321 COPELAND DRIVE LAKE COPELAND HISTORIC DISTRICT

Major Certificate of Appropriateness to demolish the existing structure and rebuild in a new style.

PROPOSED ELEVATIONS OF HOUSE

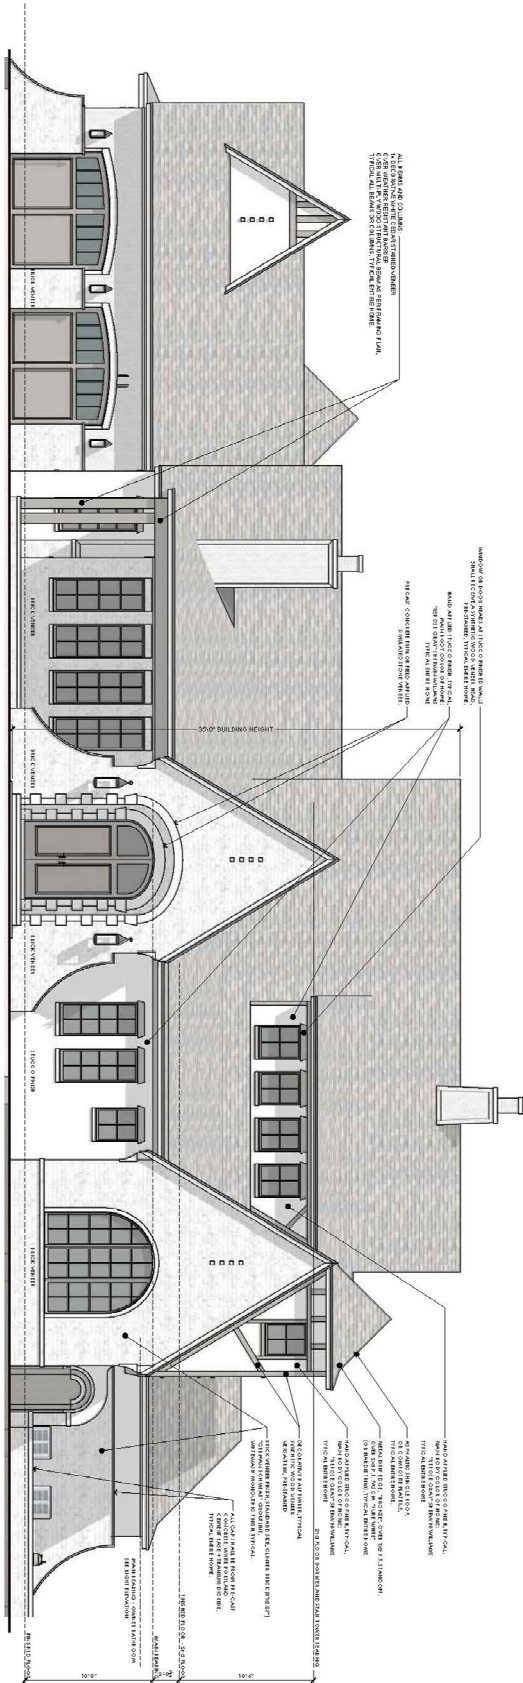
The proposed new structure draws from Tudor Revival influences which are not prevalent in the Lake Copeland Historic District. The height and scale of the structure is much larger than the existing building and the surrounding structures. No calculations have been provided regarding transparency. Windows are a mixture of fixed and casement as noted on the floor plans.

HEIGHT STUDY BY APPLICANT

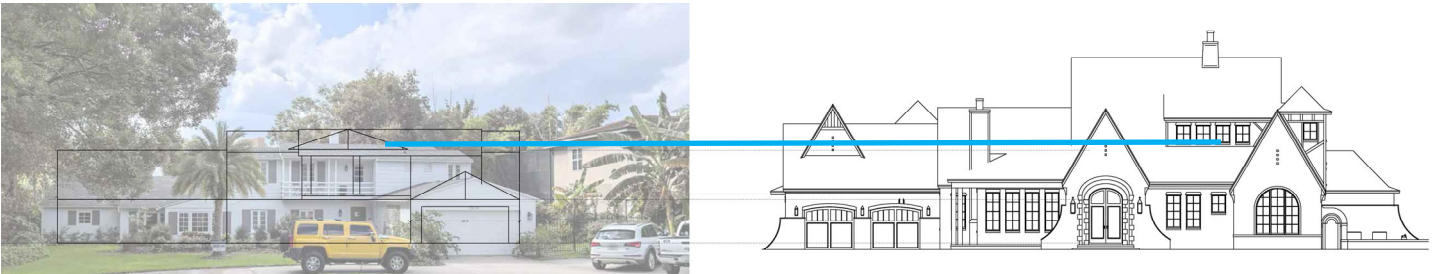
The height of the proposed structure is 29'-6", just 6" below the max. allowable. No address is given for the comparison study but it appears to be 1315 Delaney. Staff cannot confirm the scale is the same in the two images. However, it should be noted that 1315 Delaney is setback 51 ft from the lot line. It's 2 story mass is therefore reduced by its placement deeper in the lot than what is proposed at the subject property.

Although corresponding lines are not provided by the applicant, the roof is lower on 1315 Delaney.

The height of the proposed structure is 29'-6", just 6" below the max. allowable. The comparison house shown here is 1304 Delany, immediately North of the subject property. Staff cannot confirm the scale is the same in the two images. It should be noted that the lines drawn over the image of 1304 Delaney are incorrect and do not accurately reflect the roof shape. 1304 Delaney does not have a forward facing gable on the second floor. It is also setback 81 ft from the lot line. Its 2 story mass is therefore reduced by its placement deeper in the lot than what is proposed at the subject property.

Since the corresponding lines are not provided accurately by the applicant, the roof is lower on 1304 Delaney. Actually, the 2 story structure at 1304 Delaney is lower than the 1 story roof proposed over the garage.

HEIGHT STUDY BY APPLICANT

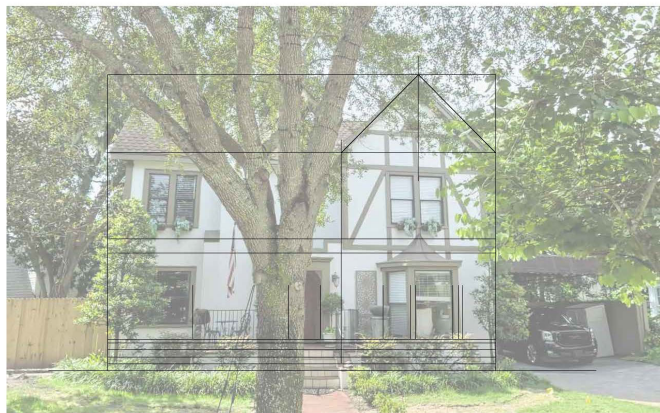
The height of the proposed structure is 29'-6", just 6" below the max. allowable. The comparison house shown here is 120 Fernwood, which is more than 2 blocks away from the subject property. And was not considered by staff for comparison but is a Tudor Revival home. Staff can not confirm the scale is the same in the two images. Additionally, no corresponding lines were provided by the applicant.

LIVING SQUARE FOOTAGE COMPARISON

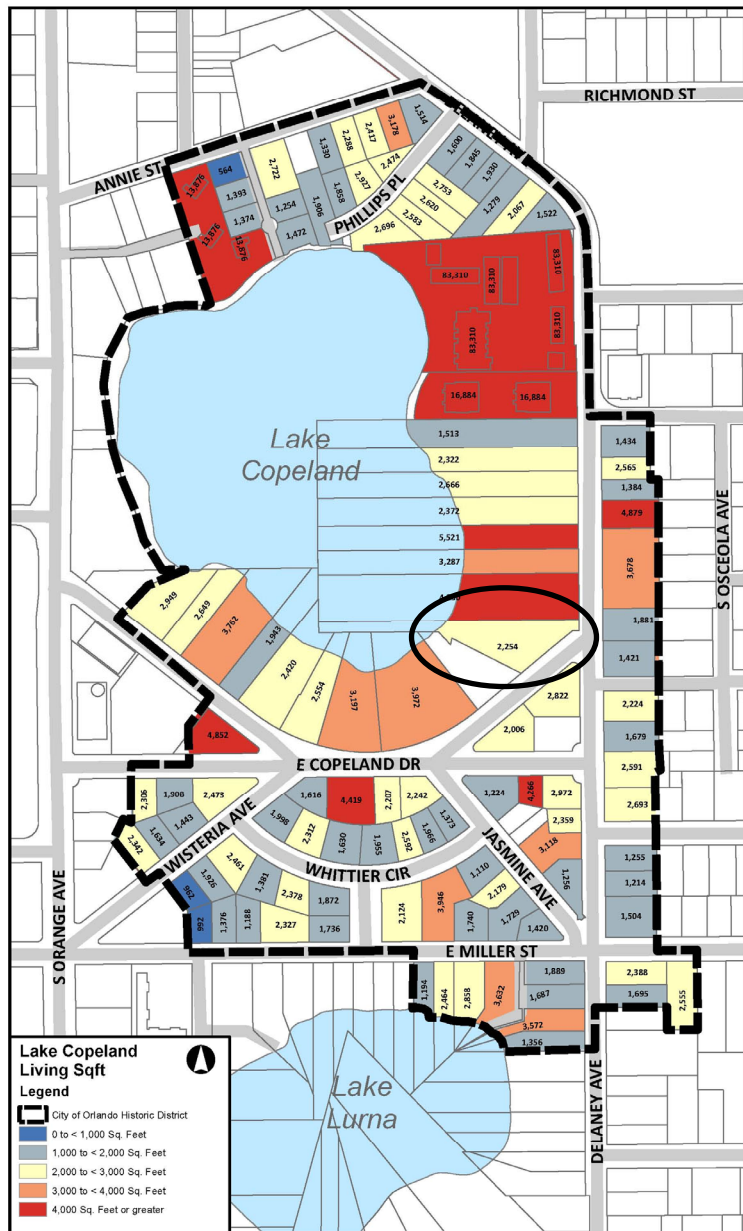
- Per the Property Appraiser, the house currently has 2250 sqft. of living space.
- The new SFR will have 4,622 sq ft, more than double the current house.
- The color indicator would change to RED, which is larger than the size of the surrounding contributing properties except one.
- FAR would be .18.
- The average living sq ft of abutting properties is 1,421 sq ft to 4,250 sq ft.
- The site will have more square footage than all neighboring properties, except one.

GROSS SQUARE FOOTAGE COMPARISON

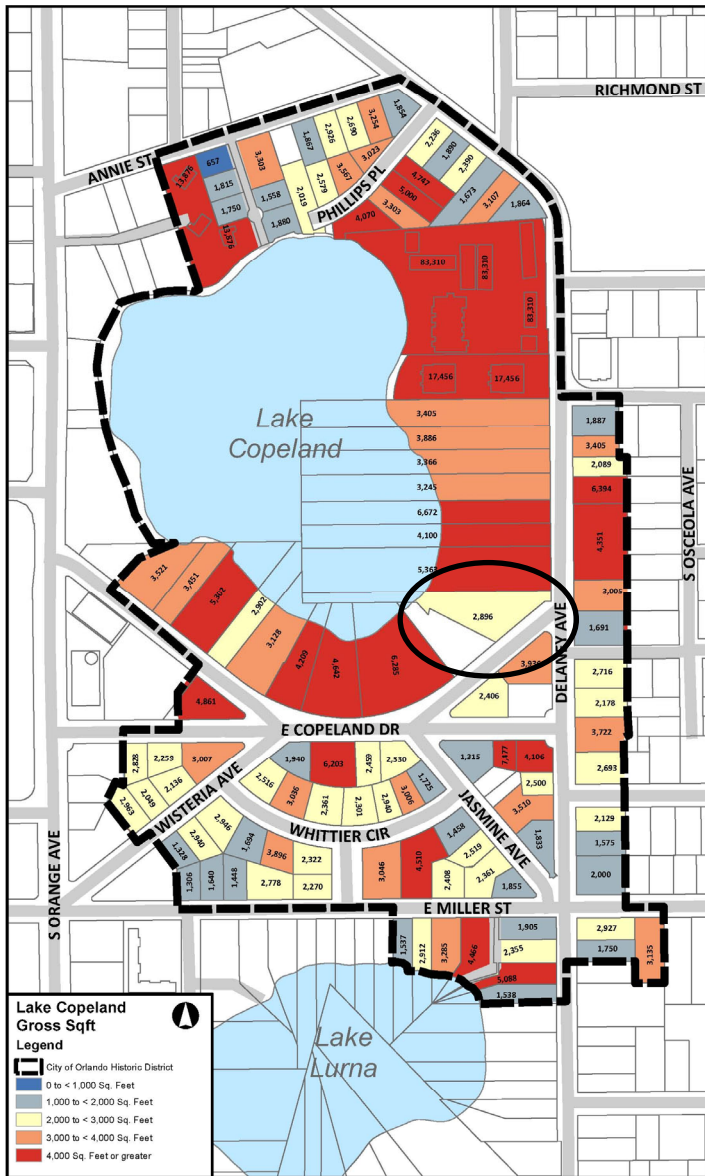
- According to the Property Appraiser, the site currently has 2892 sqft of gross square footage, which compares to the YELLOW colored properties.
- Staff was unable to determine the gross sq ft from the information provided. The building pad is described as 6,585 sq ft., which includes the living areas, rear porch, front porch, and second floor rear balcony.
- The immediate surrounding contributing structures within the Lake Copeland Historic District are between 1,691 sq. ft. to 6,285 of gross square footage.
- This property would have a gross square footage in excess of the majority of contributing structures in the surrounding area.
